Fingerboards Mineral Sands Project Inquiry and Advisory  
Committee - EES

**WGCMA Ref:** WG-F-2017-0139-03  
**Your Ref:** EES The Fingerboards  
**Date:** 28 October 2020

**Regarding:** Fingerboards Mineral Sands Project

**Figure 1 – Location of Chain of ponds in proposed Project area**

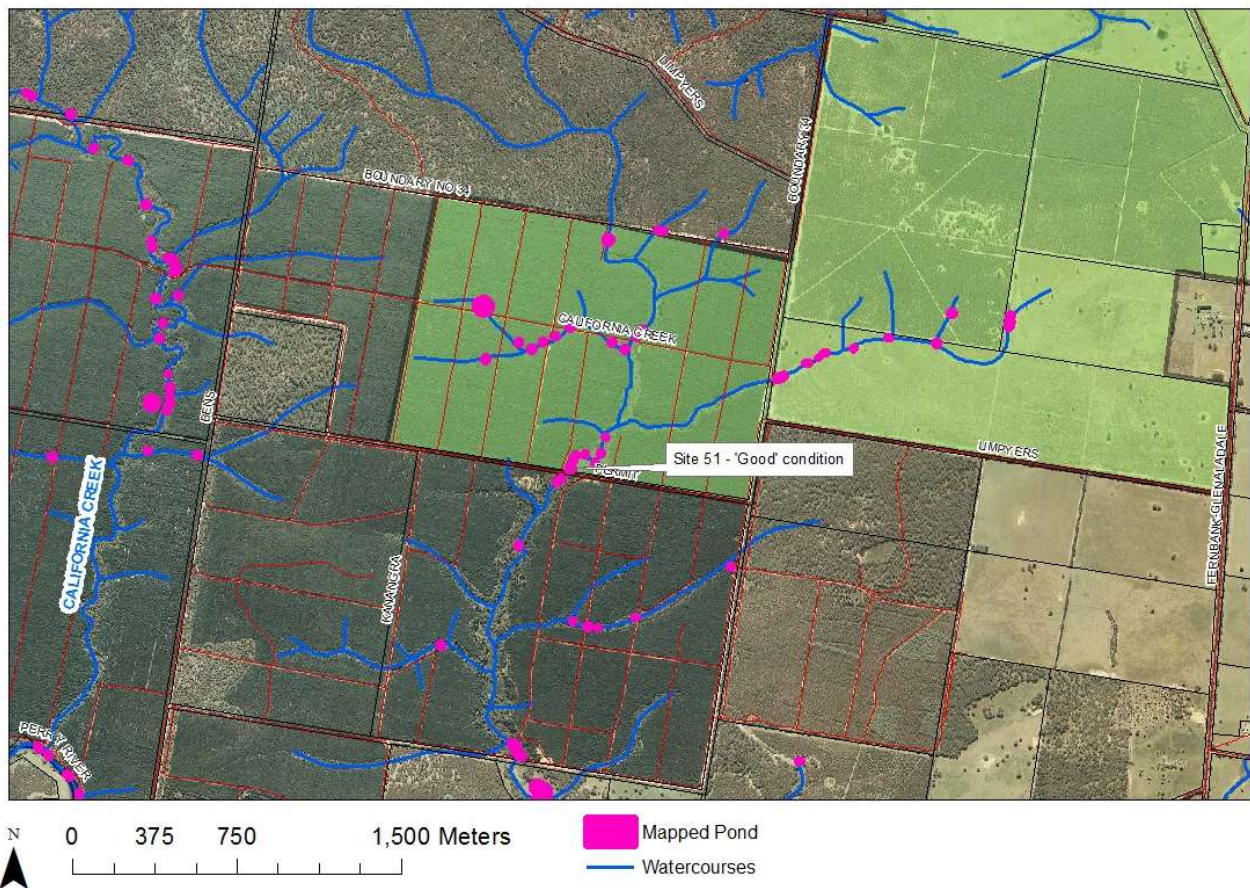
Figure 1 shows the location of the chain of ponds within the mine area, on a tributary of Honeysuckle Creek. There are 27 mapped ponds included in the proposed mine area, including site number 51 that was included in the baseline condition assessment and assessed as being in 'good' condition (according to Index of Wetland Condition and Vegetation condition categories).

Mining of this area would result in the permanent loss of these significant geomorphic features.

**Figure 2 – Location of Chain of ponds in relation to Project infrastructure**

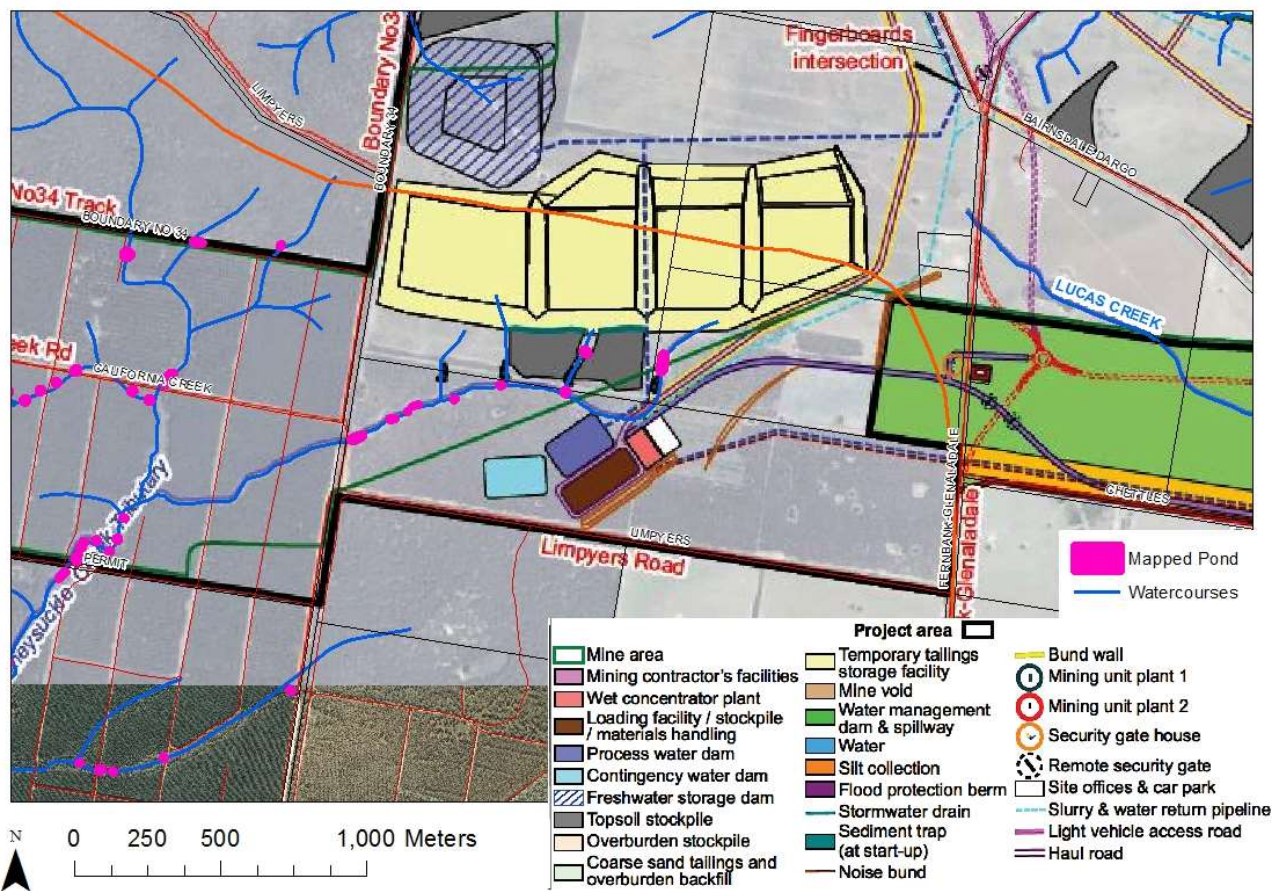
Figure 2 indicates that the mapped ponds are in close proximity to the proposed topsoil stockpile, temporary tailings storage facility, process water dam, wet concentrator plant and overburden stockpile (as shown in Figure 3 from the Map Book).

Increased sediment load in the Perry River catchment may result in the permanent loss of some ponds due to infilling. Additional impacts of increased sediment loads are the loss of wetland habitat, altered water regimes and changes to the depth, shape and bathymetry of the wetlands.

**Figure 3 – Location of chain of ponds in relation to proposed water management dam locations**

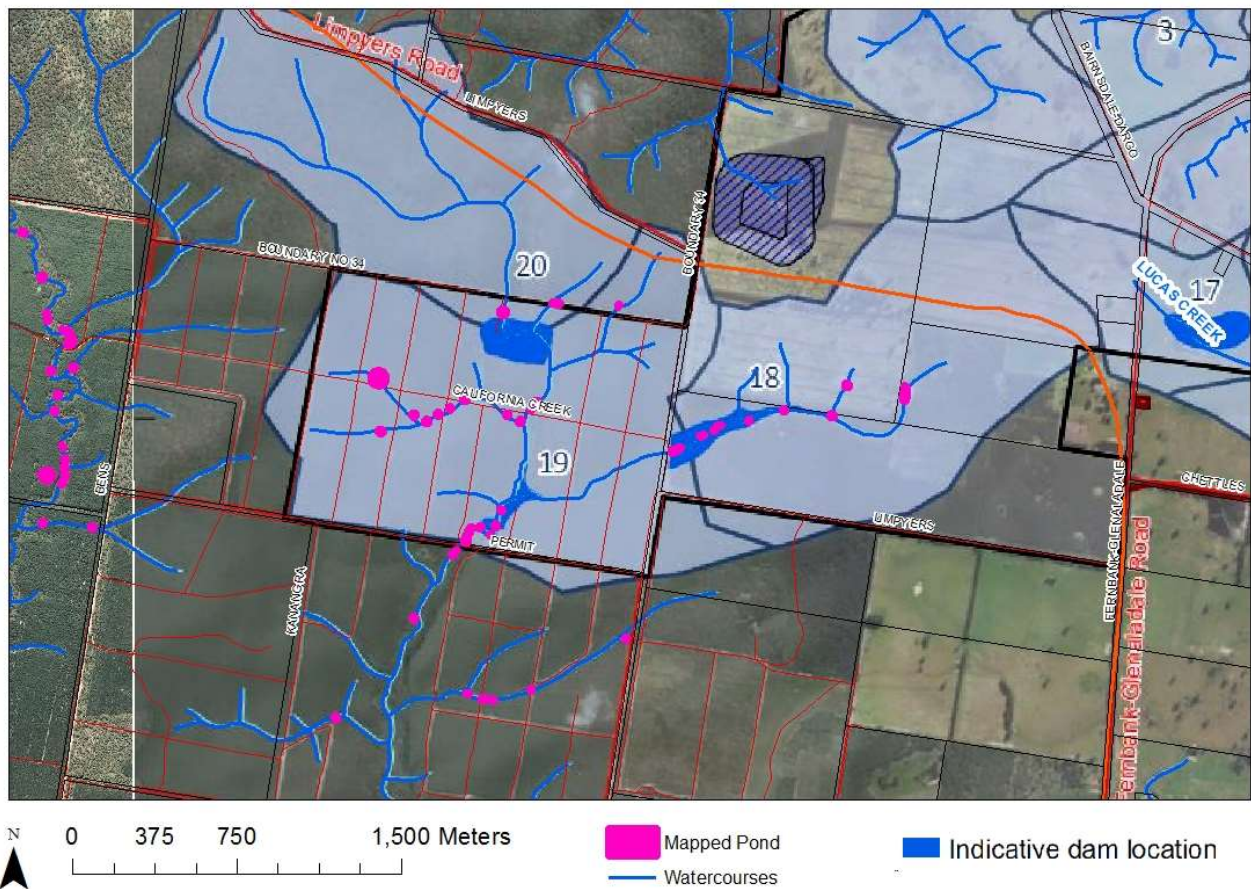
Figure 3 shows that the indicative locations for water management dams are mapped ponds. Construction of dams in these locations would result in the permanent loss of these ponds and contribute to the degradation of this rare and significant ecosystem.

Additionally, discharge from water management dams during peak storm events is likely to contain elevated sediment loads, which will negatively impact the ponds further downstream.

As seen Figure 3, three of the proposed water management dams are located in the upper reaches of Honeysuckle Creek and Providence Ponds. The construction of these dams would result in the excavation of 14 ponds.

Dam 18 is proposed to be constructed in year 3 and retained until year 16. Dams 19 and 20 would be built in year 16 and retained until years 16. Chapter 11 (Closure) states that these dams may remain in-situ for future agricultural use, meaning that the existing chain of ponds in this tributary of Honeysuckle Creek would be permanently lost.
